STEP BY STEP EARLY LEARNING CENTER

JULY 09, 2024

1st Review
PRCCP20241109
August 2024

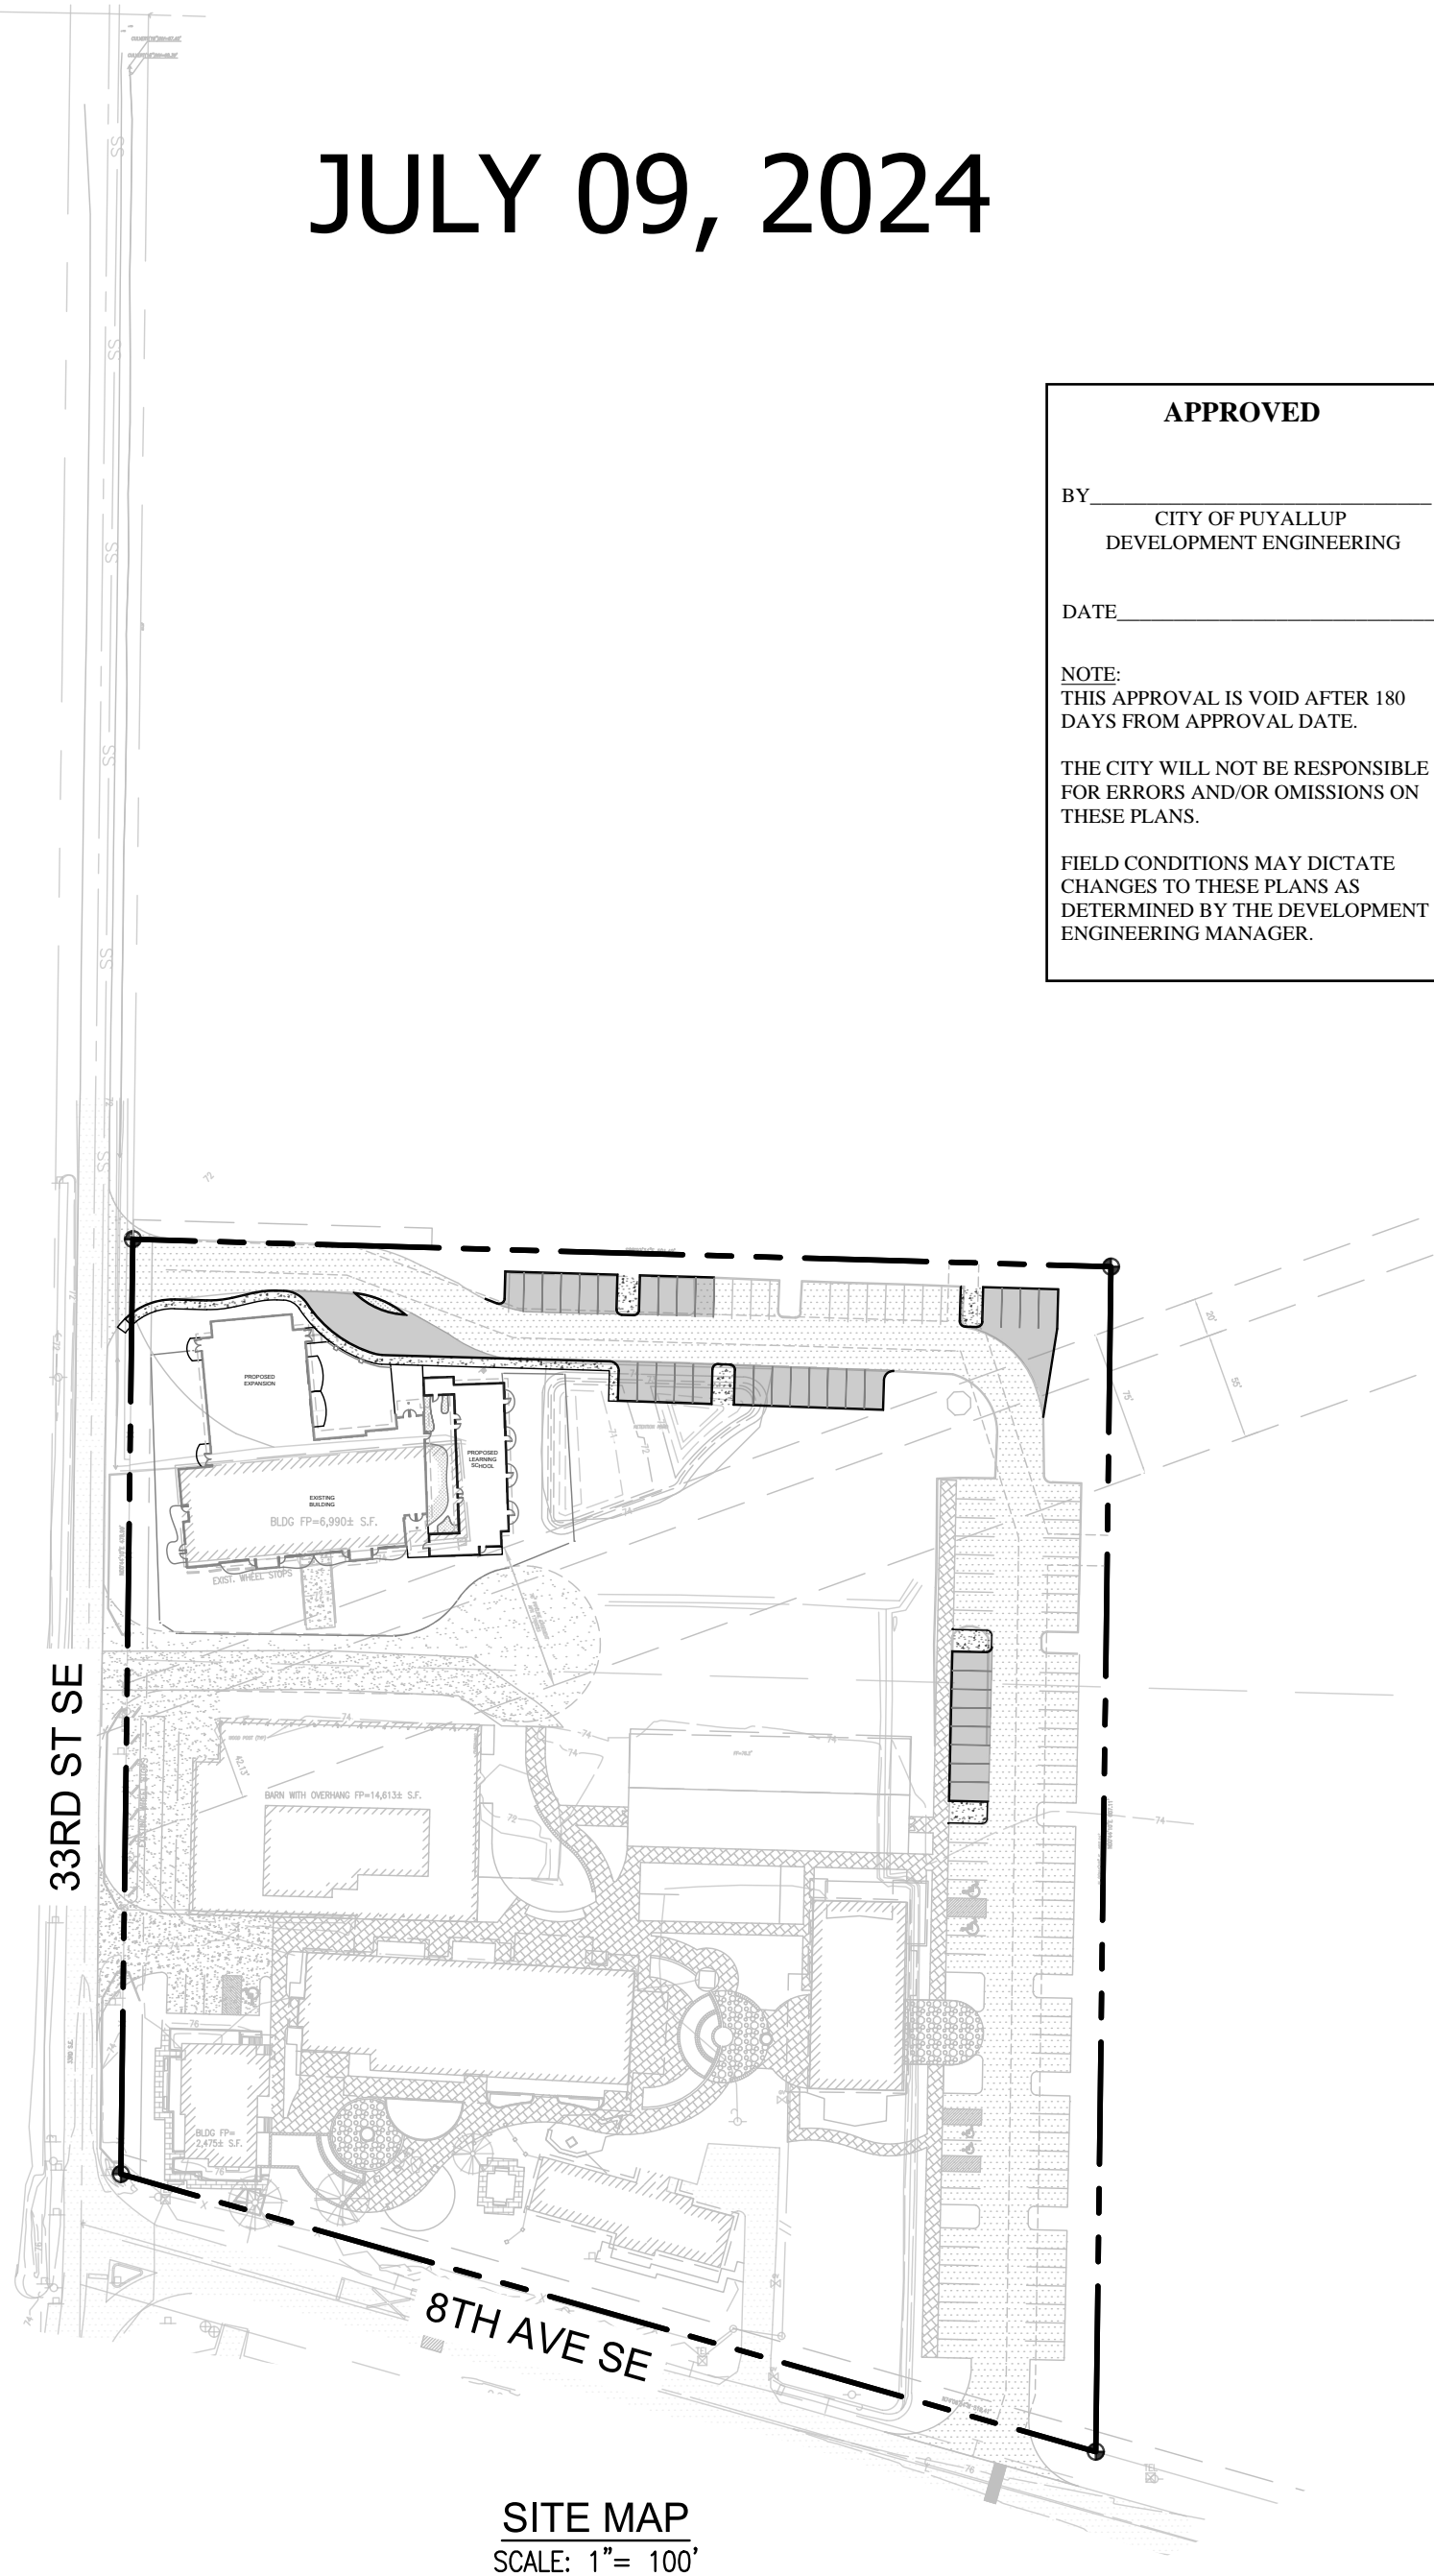
Add:
-City Standard Stormwater Notes.
-City Standard Sewer Notes.
-City Standard Water Notes (for Fire)
-City Standard Grading & Sedimentation Notes.
(Plans, Sheet C0.00)

Layout Cover Sheet in accordance with City Standards Section 2.0 General Plan Requirements. (Plans, Sheet C0.00)

Add City Engineering approval block to each sheet. (Plans, Sheet C0.00)

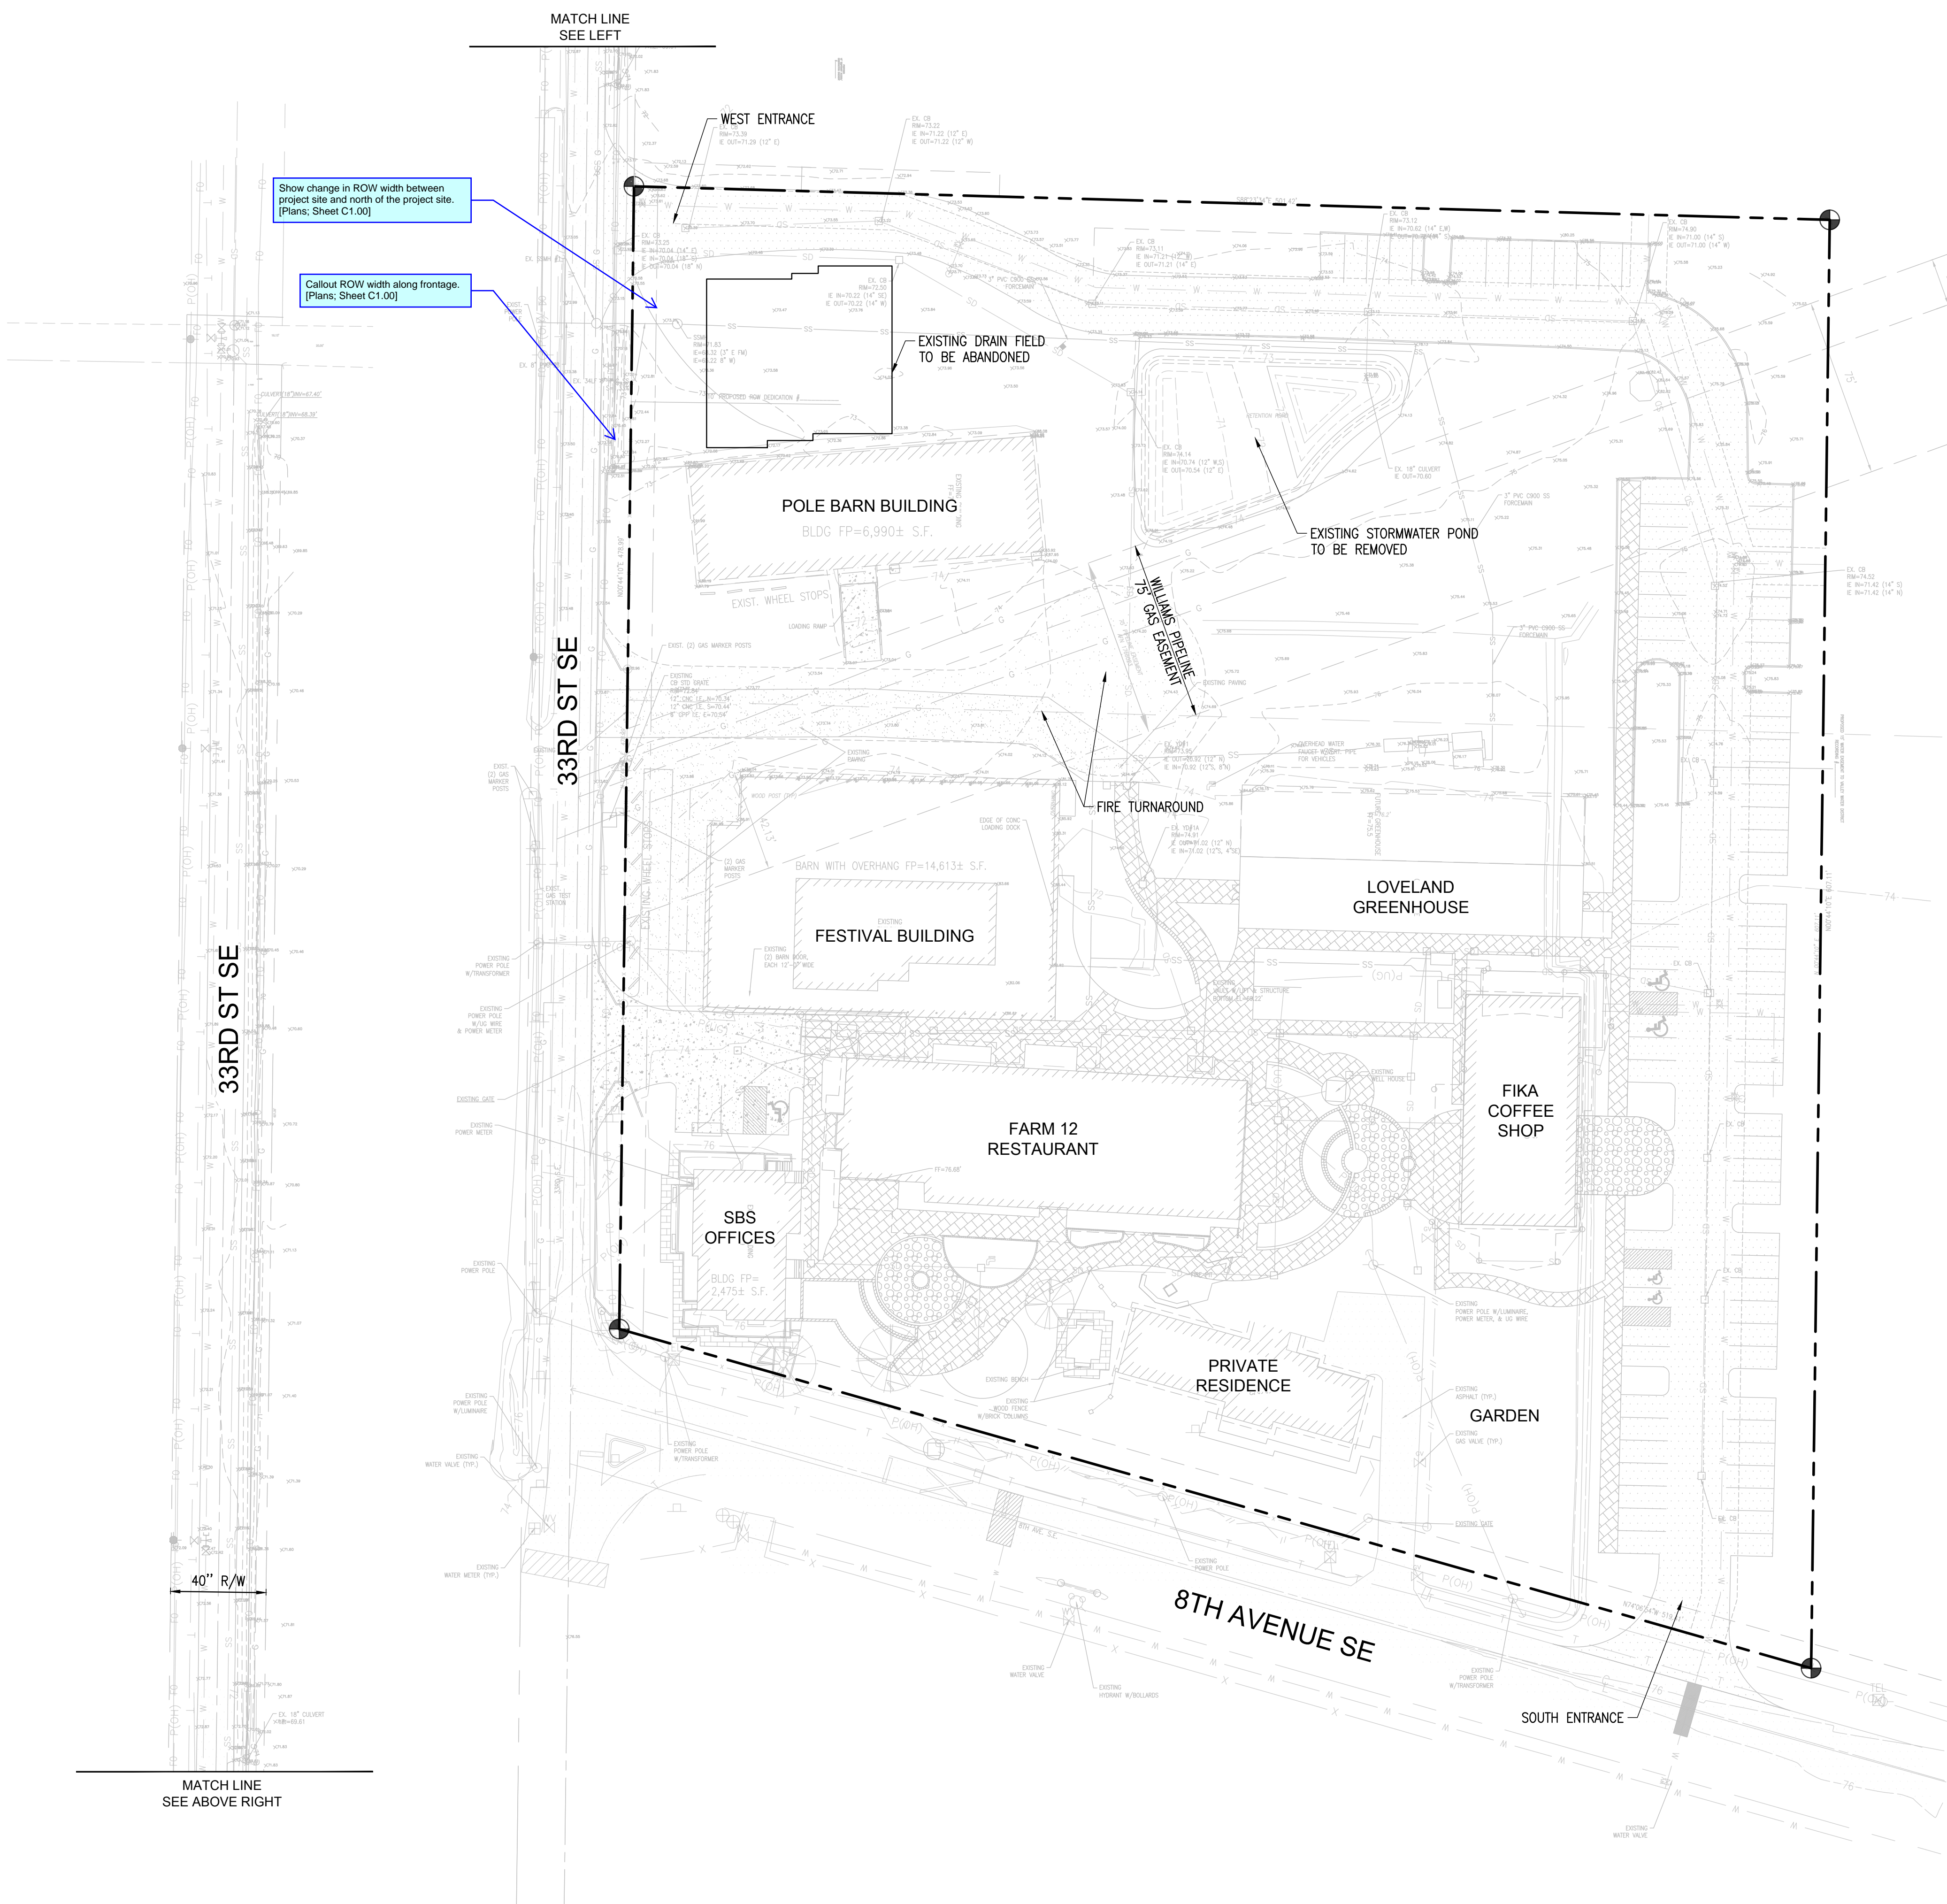
Show change in ROW width between project site and north of the project site. [Plans, Sheet C1.00]

Callout ROW width along frontage. [Plans, Sheet C1.00]

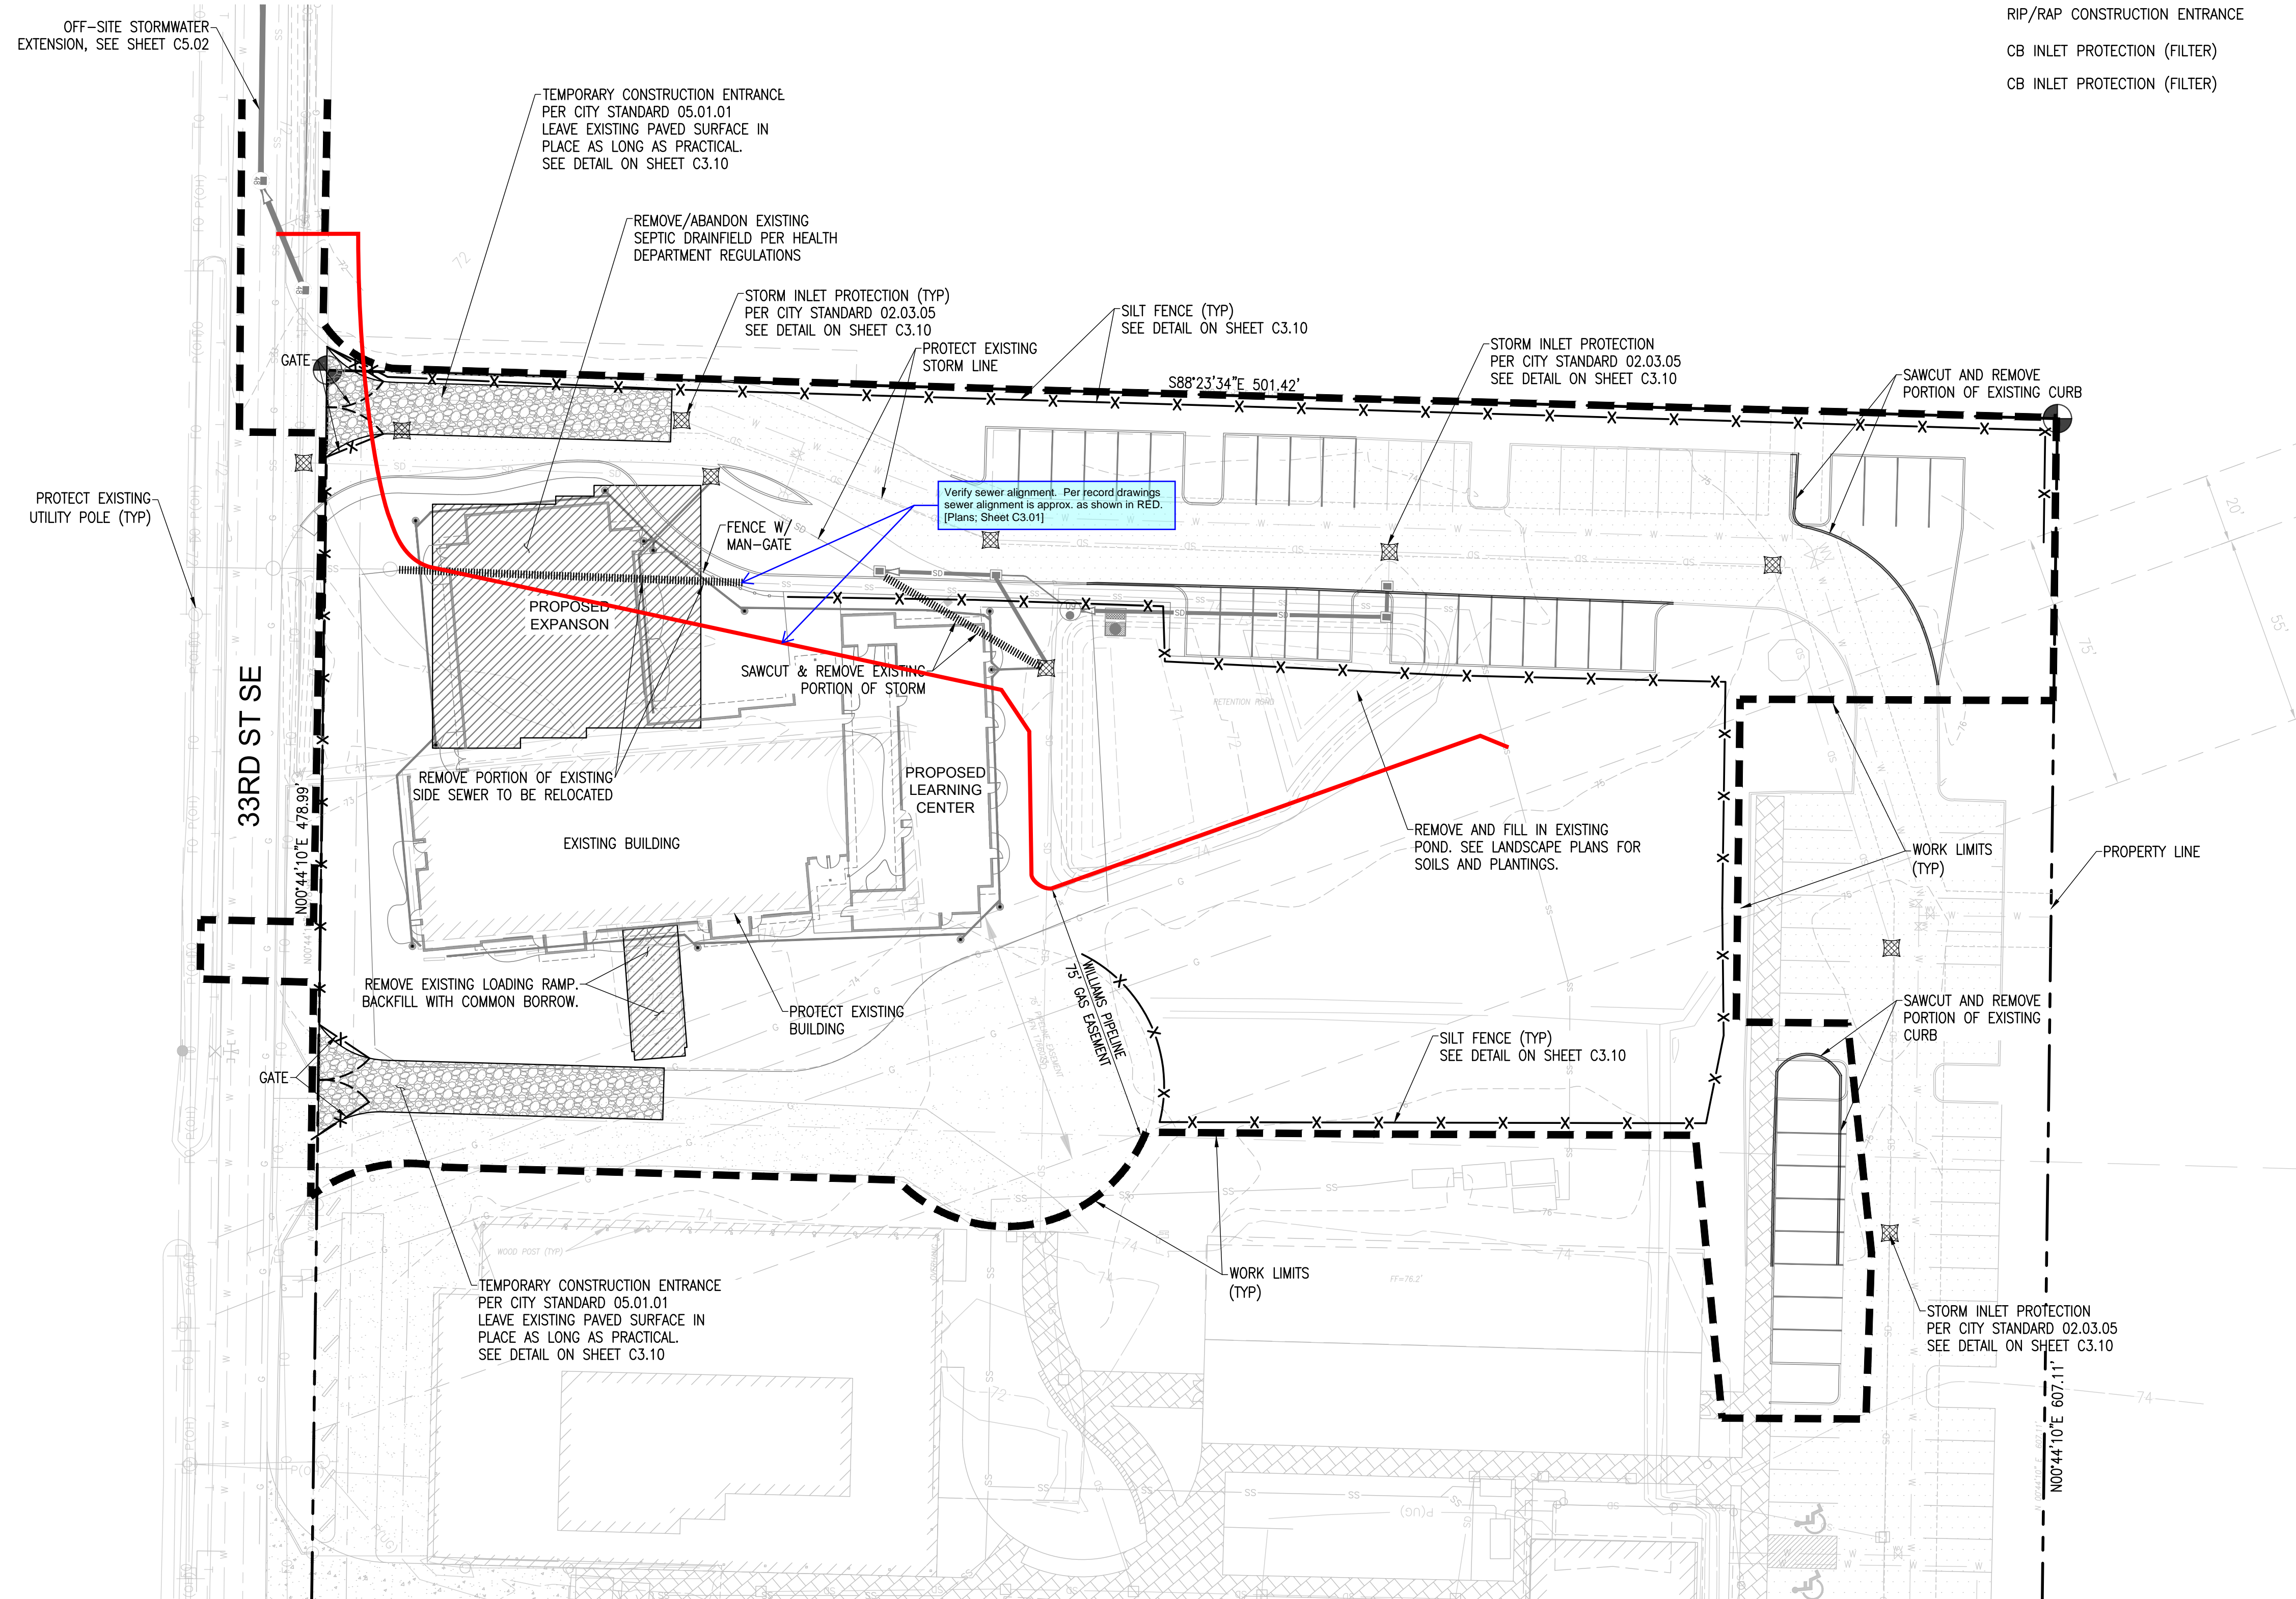
Provide Construction Sequences per City Standards Section 501.4. [Plans: Sheet C3.01]
